Planning Commission Staff Report

Meeting Date: February 28, 2022

Petition: **P.Z. 18-2021 Legends at Schoettler Pointe (Stock and Associates)**: A request for a zoning map amendment from an “E-1/2 AC” Estate One-half Acre District to a “PUD” Planned Unit Development for 9 acres located on the south side of Outer 40 Road and east side of Schoettler Road (19S640152 & 19S640657).

January 7, 2022

Sheet Title: Landscape Plan
 Sheet No: L1.01
 Date: 10/15/21
 Job #: 1043.001

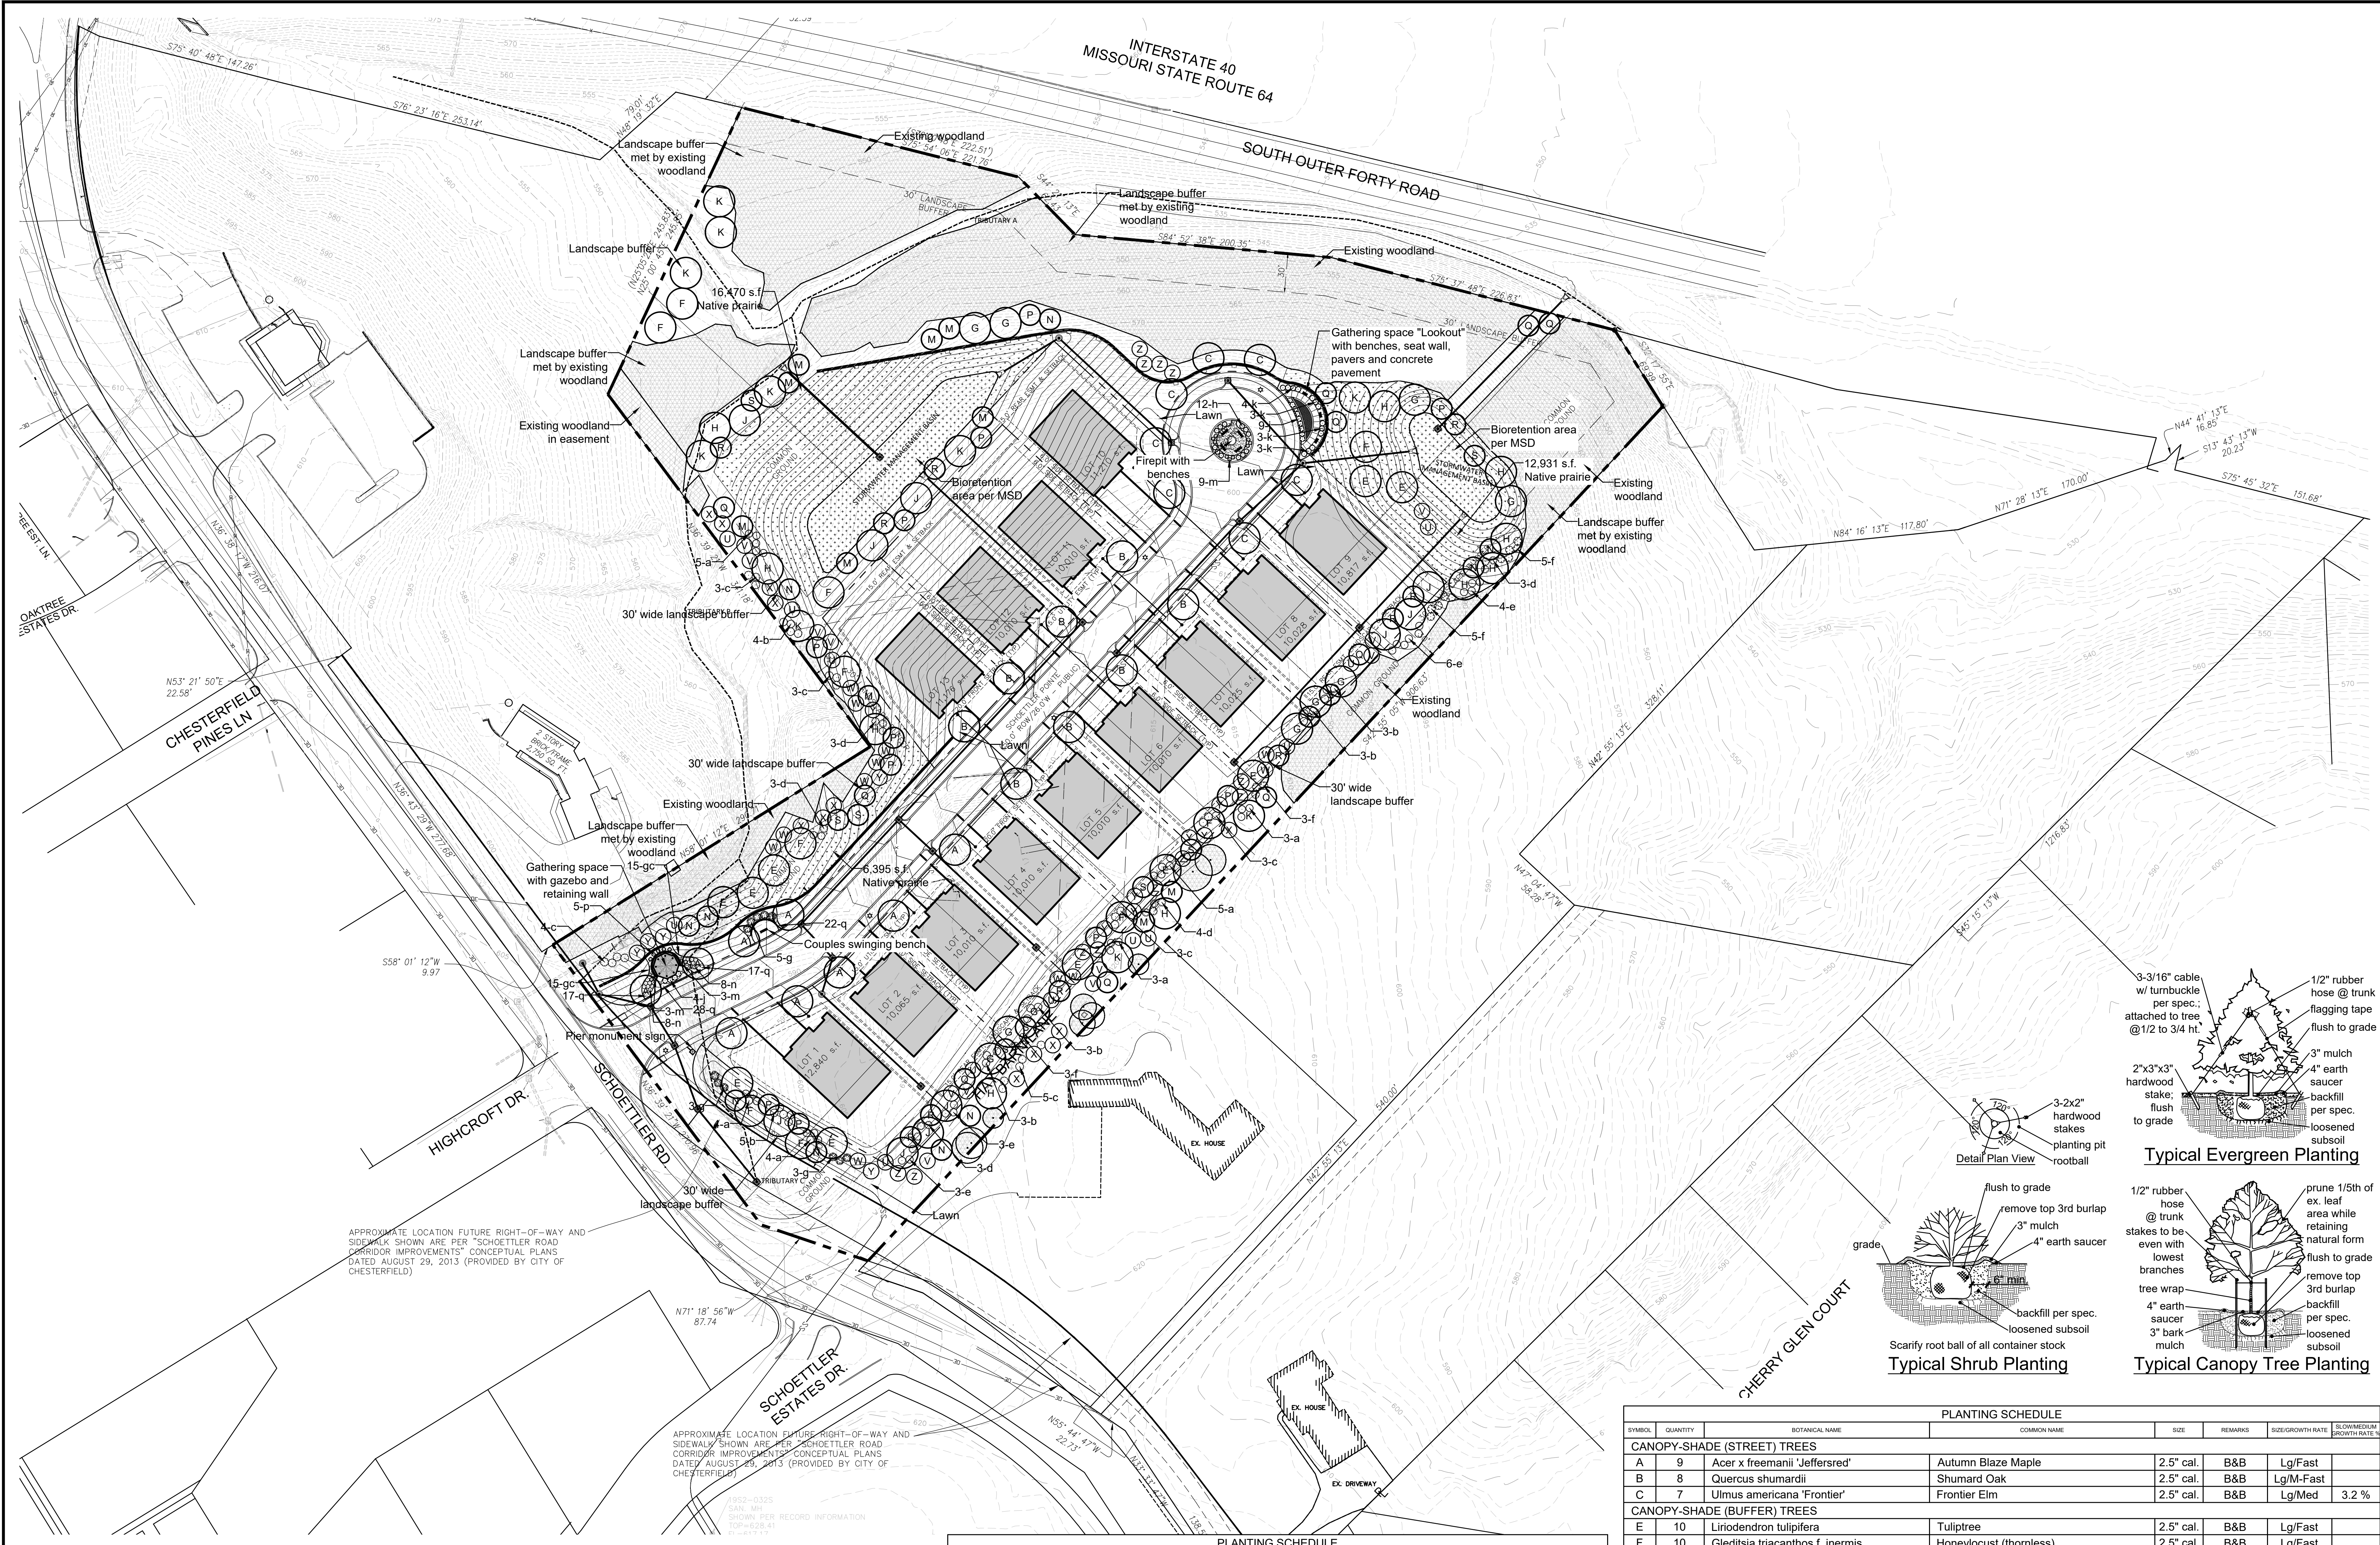
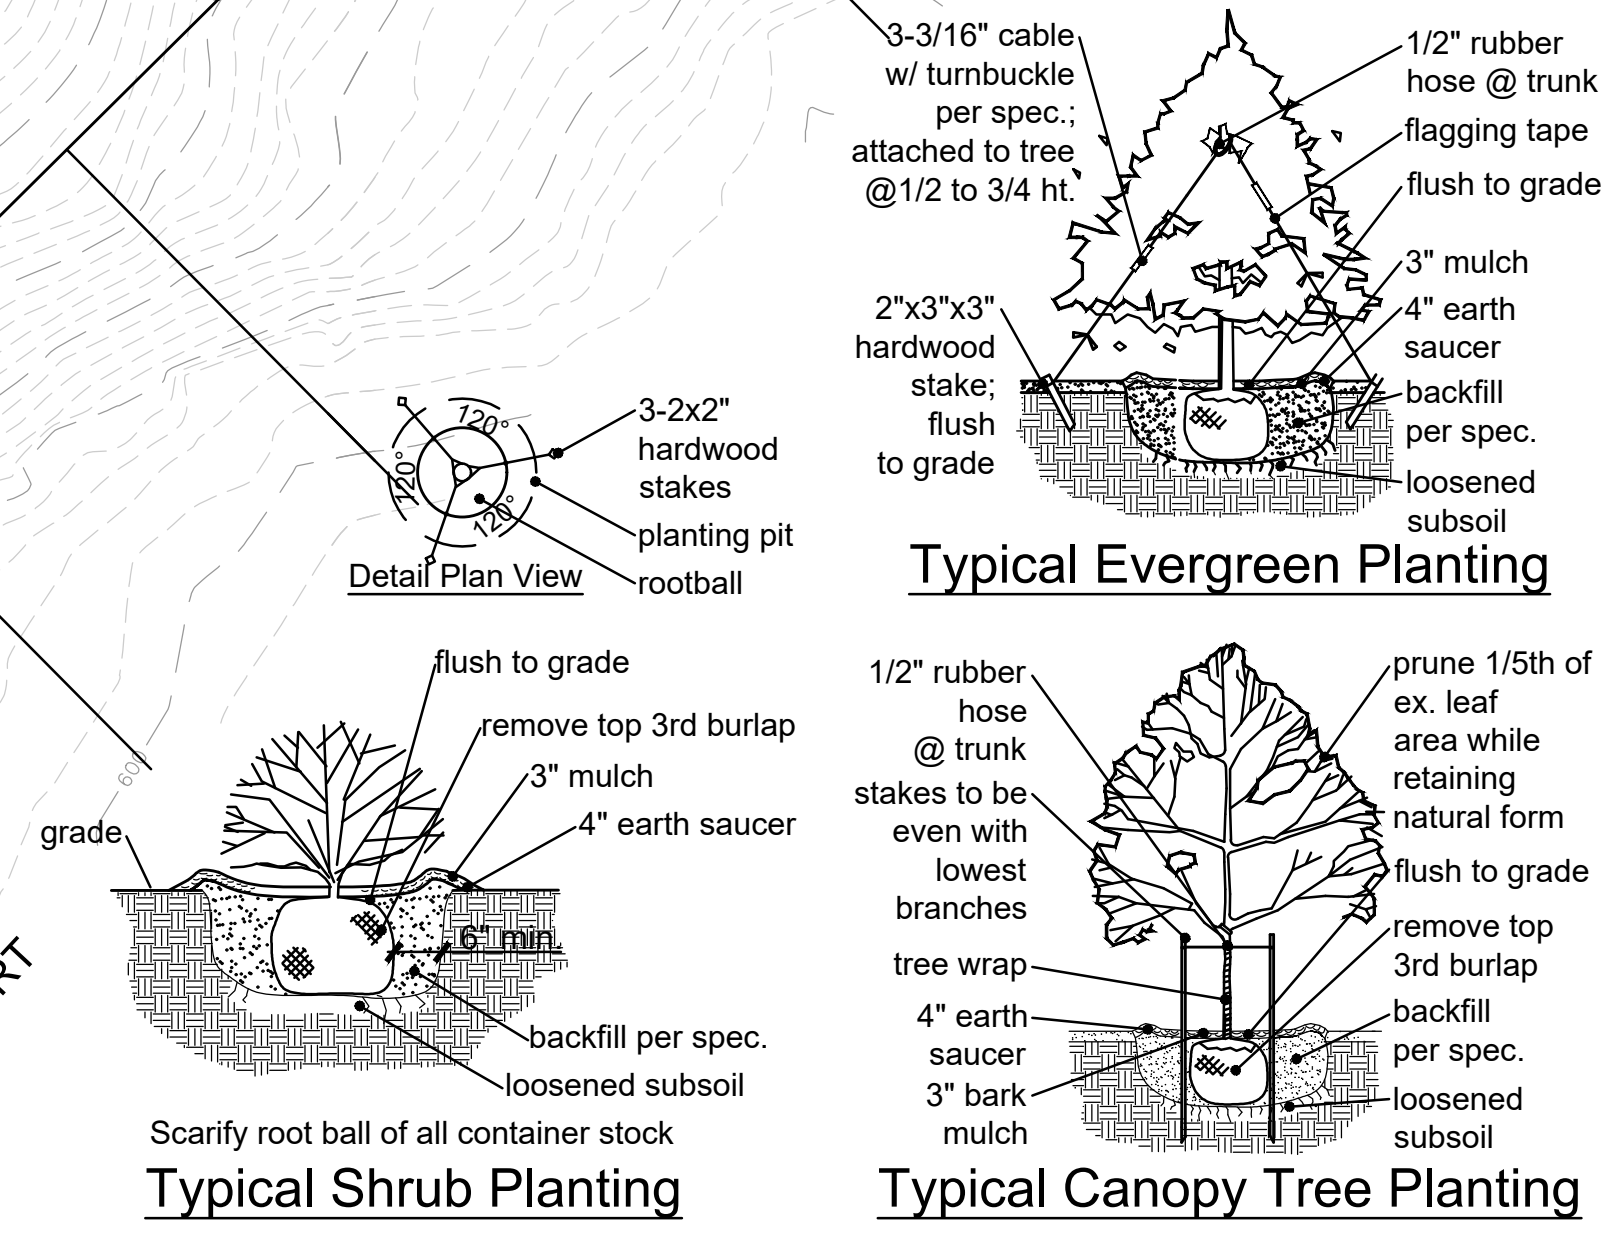
3. The landscape plan sheet is not a requirement for zoning process. The landscape plan needs to be included in the subsequent Site Development Plan package. The full landscape plan may continue to be presented to the Planning Commission but will be a supplementary exhibit and not approved with the zoning request.

Response: Understood, Landscape Plan will be included in subsequent Preliminary Development Plan submittals.
